**Re: Hanlon Creek Business Park Environmental Implementation Report  
Outstanding Items**

# **Agency and Environmental Group EIR Comment Table**

Rajan Philips, P.Eng.  
Manager of Transportation Planning &  
Development Engineering  
(519) 837-5604, ext. 2369  
[rajan.philips@guelph.ca](mailto:rajan.philips@guelph.ca)

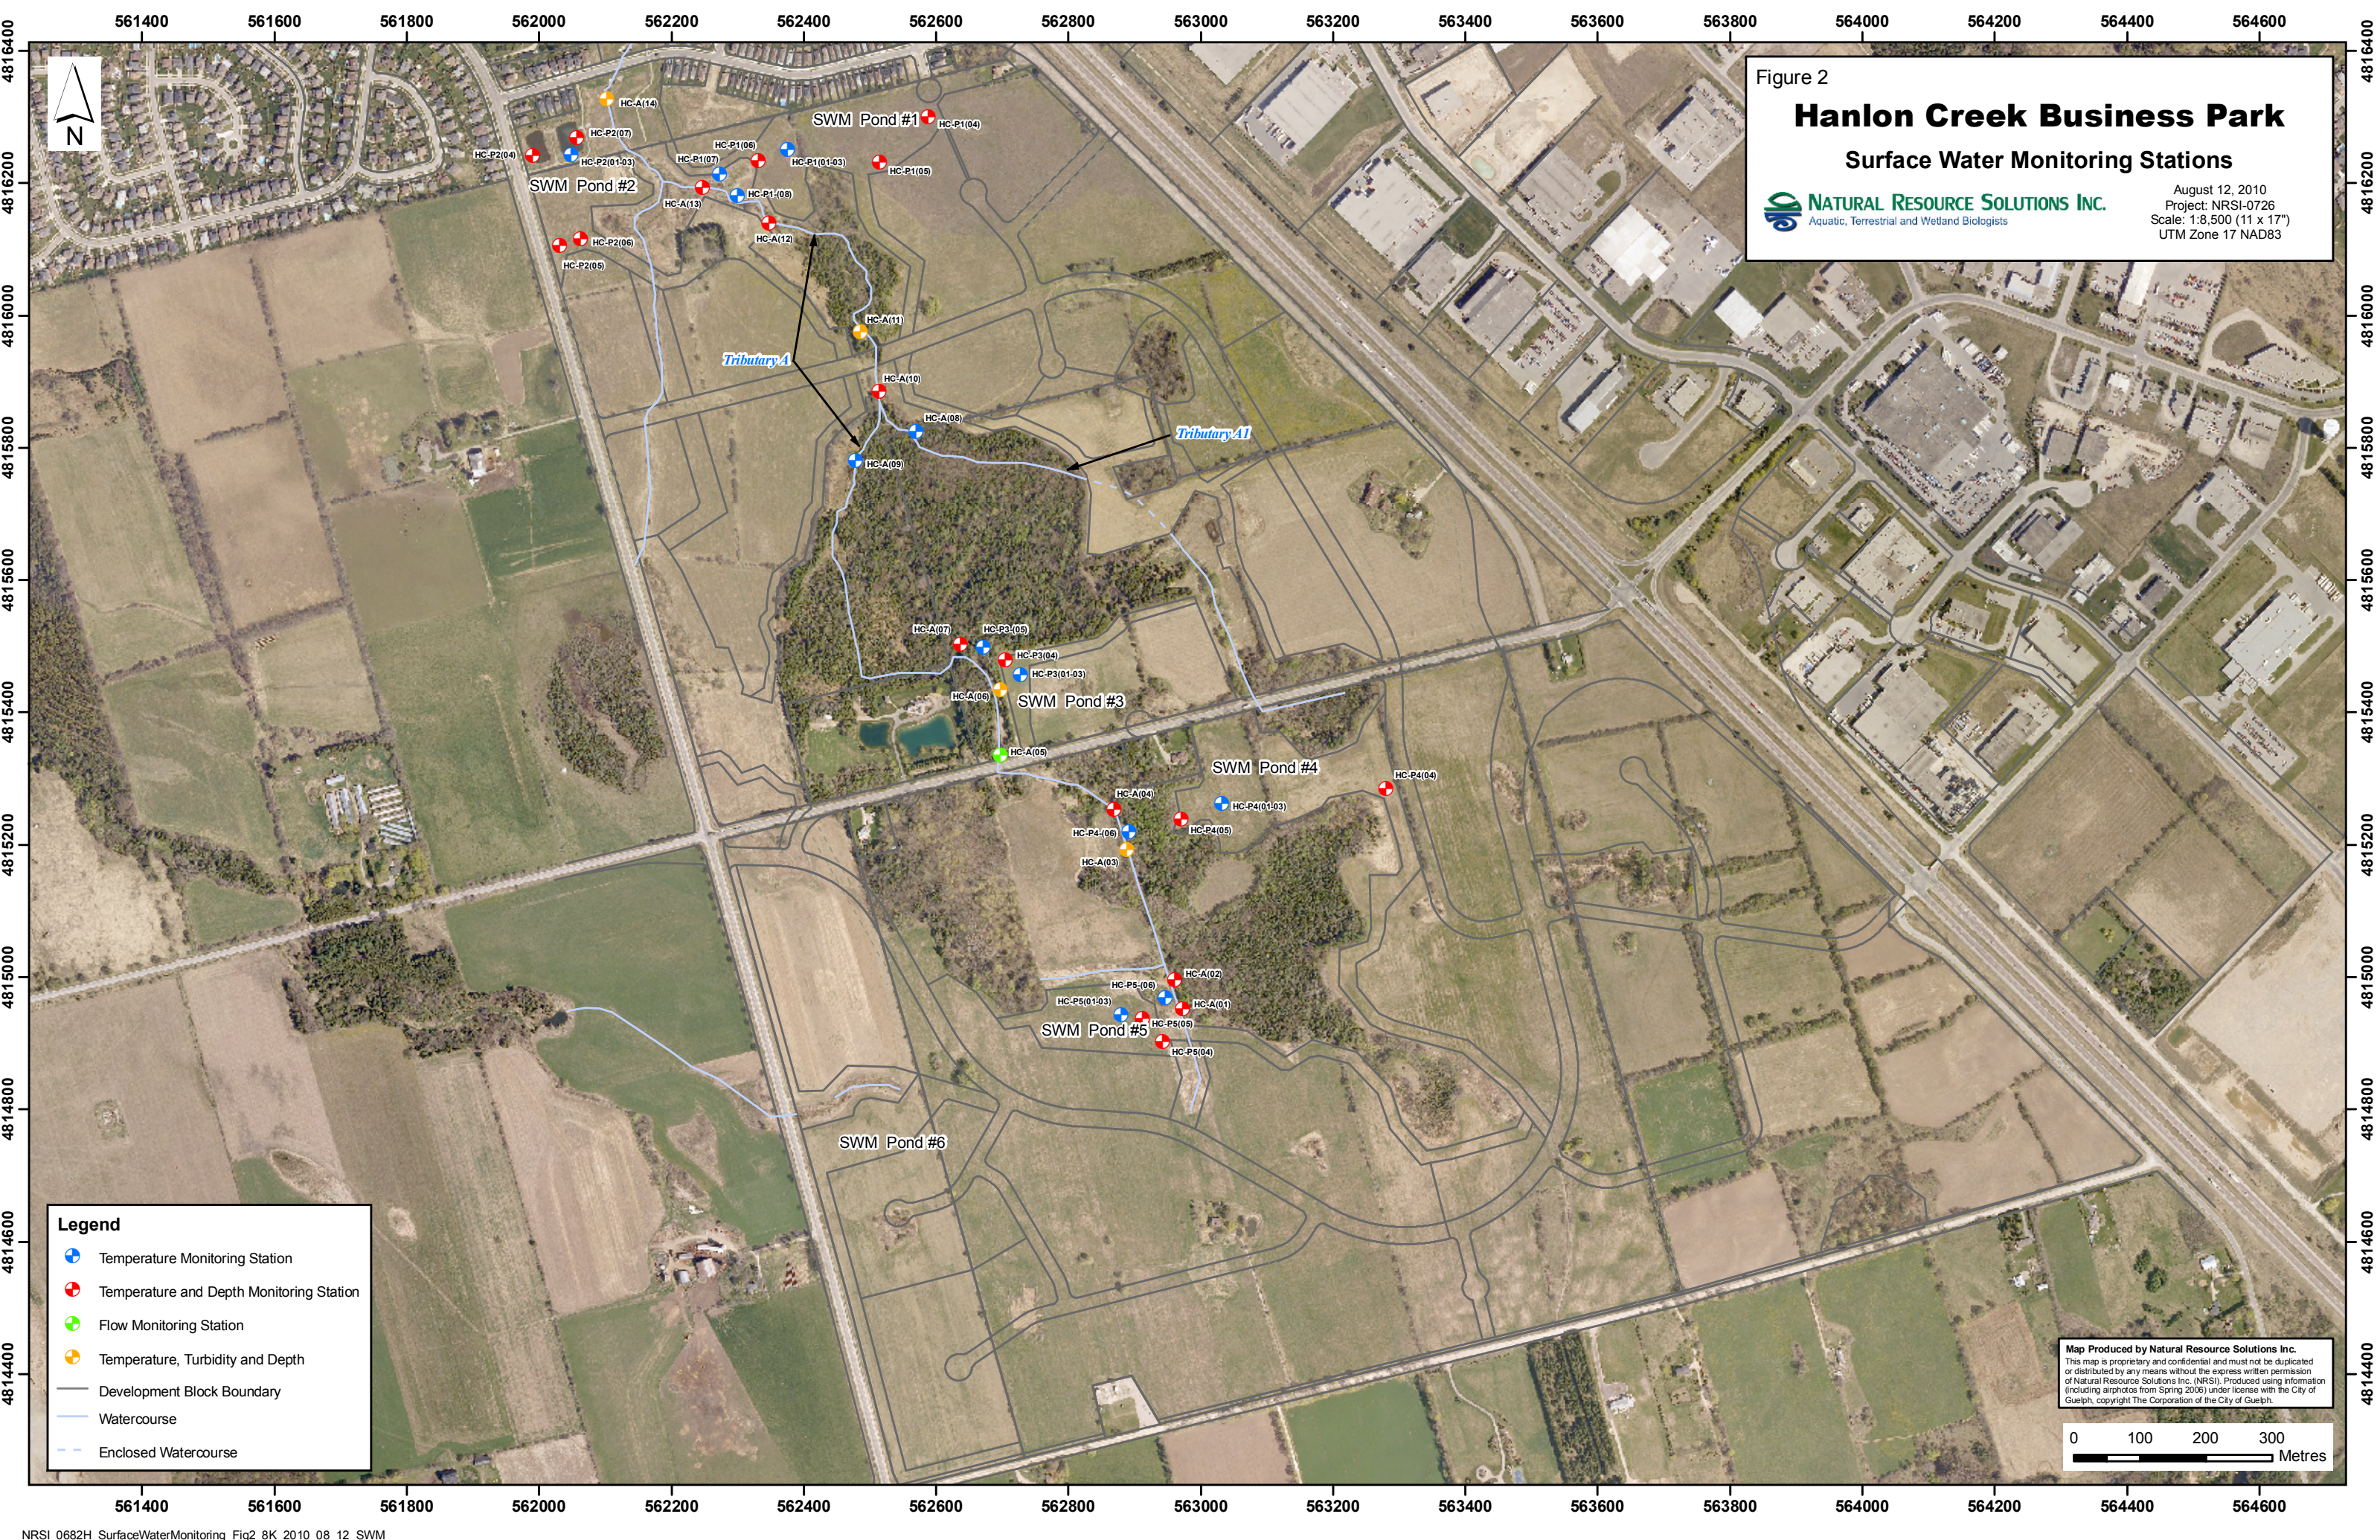
Source of Comment	#	Nature of Comment	Response	EIR Reference (NRSI February 2009)
Colin Baker - Community Design and Development Services, Engineering Services, City of Guelph (May 7, 2010)	71	d) Section 6.2 - All surface water monitoring locations must be shown on a figure and labelled with the monitoring location name. From the SWM pond monitoring plan under Methods, it does not appear that the SWM Pond outlet flowrates will be continuously monitored as required by the C of A.	A review of the naming convention of monitoring sites within the HCBP has been completed with all monitoring stations anticipated for 2011 as shown in attached Figure. The naming convention has been updated based on the addition of monitoring sites in the 2010-2011 monitoring program. The provided naming convention includes a watershed description, general location (tributary name or pond number) and numbering in chronological sequence. For example station HC-A-05 is located within the Hanlon Creek Watershed, within Tributary A and is the fifth station. This format will allow for a general identification of the station based on the description, provide for the addition and removal of sites from the plan and allow for query based searches. A level logger will be included at the pond outlet as well as both upstream and downstream of the pond outlet. This information in conjunction with flow measurements and calculations will provide continuous estimates of pond outlet flow rates.	Appended to EIR Package - Figure 2 Hanlon Creek Business Park Surface Water Monitoring Stations
